Joint Permit Application For Work Within the Louisiana Coastal Zone

Application Number: 31230

Permit Number: P20230358

As part of the design effort for the Louisiana International Terminal (LIT), the Port of New Orleans needs to conduct pile load tests to determine the load capacity of the type of piling that is expected to be used for the construction of the wharf and ramp portions of the LIT project. Three test pile clusters would be installed on the floodside of the Mississippi River Levee (MRL) and three would be installed between the MRL and Highway 46. Each floodside cluster (locations indicated by dashed ovals in Figure 2 and pile configuration shown in dashed oval in Figure 3) would be comprised of one instrumented 36" square concrete test pile, one 36" square concrete indicator pile, and twelve 36" steel pipe reaction/indicator piles. These pile clusters would have a maximum tip elevation of -200 and would be installed no closer than 400 feet from the floodside toe of the MRL. Additional individual 36" square concrete indicator piles and 36" steel pipe reaction piles would be installed with and adjacent to the footprint of the proposed LIT wharf (locations indicated by

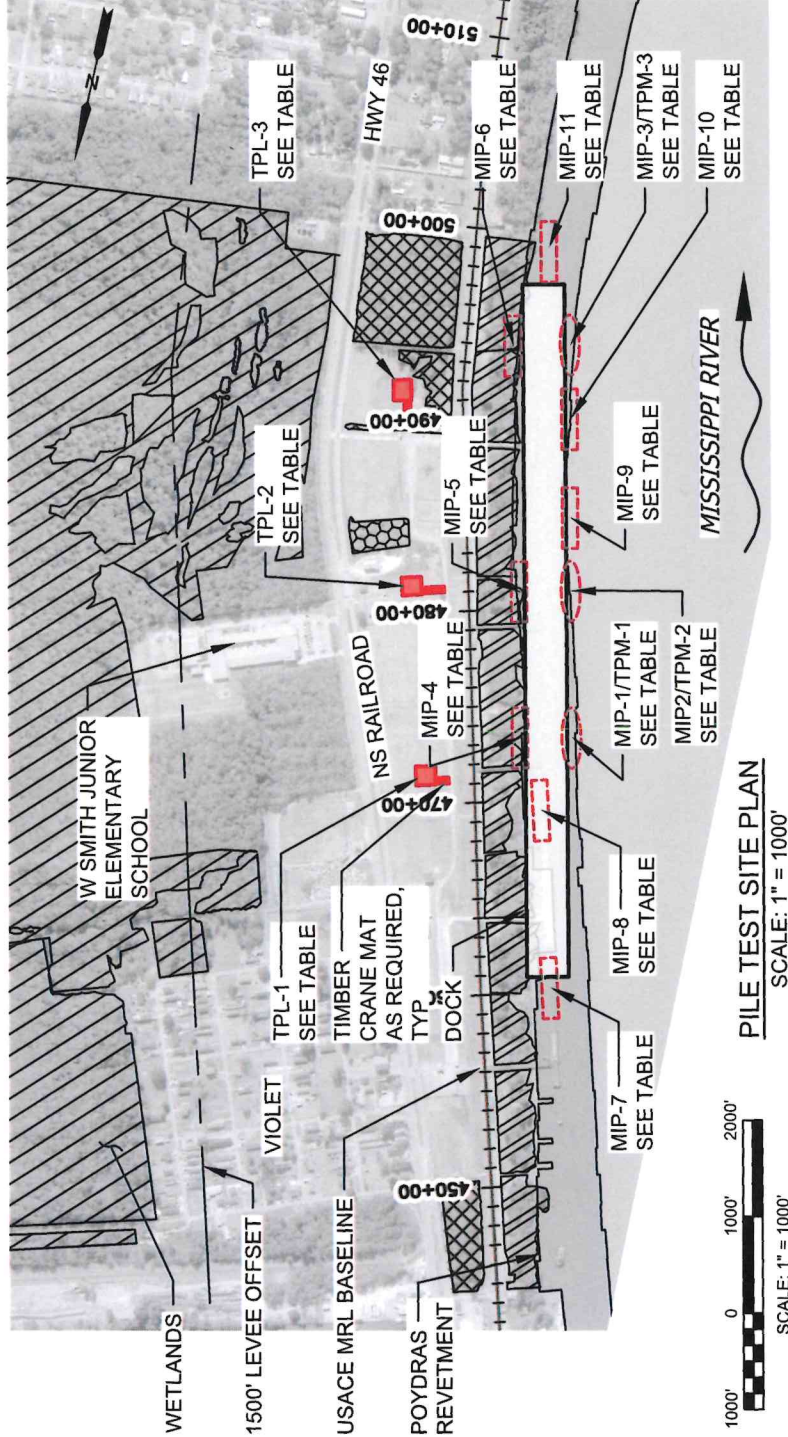
Following up on our phone call this afternoon, please provide an explanation for what will be done with the vegetation cleared from the batture wetlands.

OCM Analyst: Emily Eley (Emily.Eley@la.gov)
Final Determination: Exempt, NDSI
Application Modification: Note 7, on Figure 3 - Sheet 1 of 2 added to plats. Note explains what will be done with the cleared batture vegetation. No changes to sensitive features since last distribution on 08/15/2023.

The contractor plans to stockpile the cleared vegetation on-site and then haul it off to a landfill. They would also chip the smaller diameter vegetation (under 6-inches diameter) and leave it on site for soil stabilization/mulch.

TPL AREA PLAN
SCALE: 1" = 80'

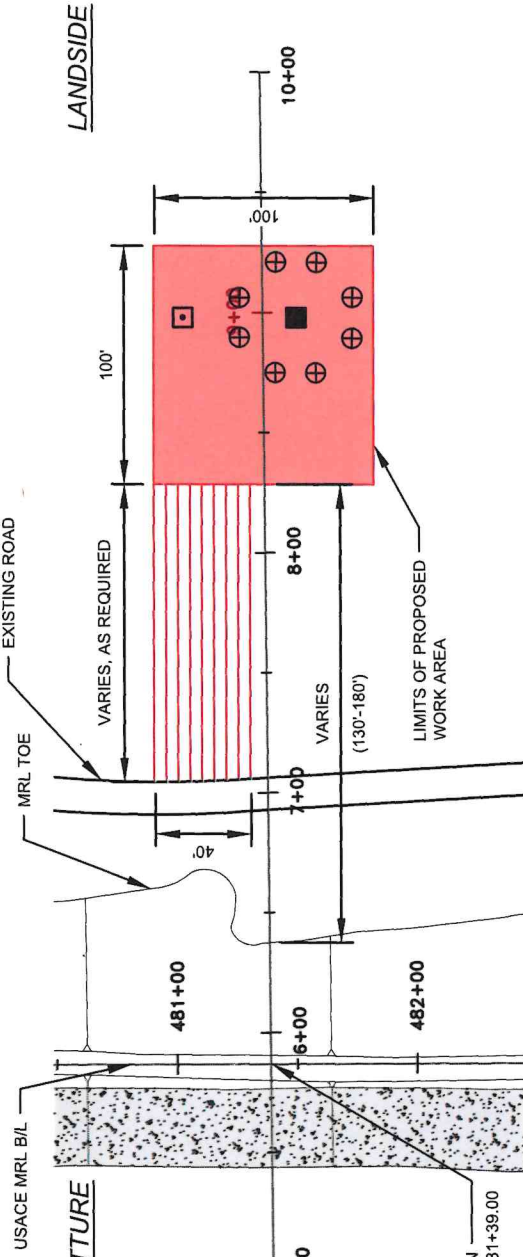
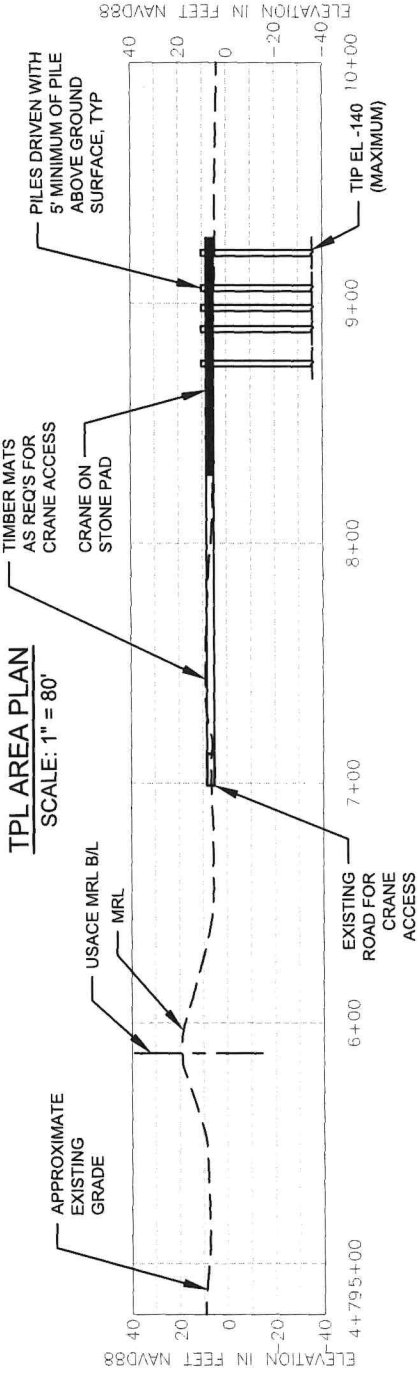
Following up on the phone call we had this afternoon, we discussed the configuration of the pilings for each test site in P20230358. As we discussed, please respond to this email confirming that the proposed configuration of test piles will be identical for all three test sites TPM-1, TPM-2, and TPM-3 (see figure 3 sheet 1/2). Additionally, that the configuration of test piles is the same for all three land-based sites TPL-1, TPL-2, TPL-3 (see figure 3 sheet 2/2).

Yes, you are correct. Figure 3 sheet 1 of 2 represents the layout for all three floodside (batture/river) sites, and Figure 3 2 of 2 represents the layout for all three landside sites.
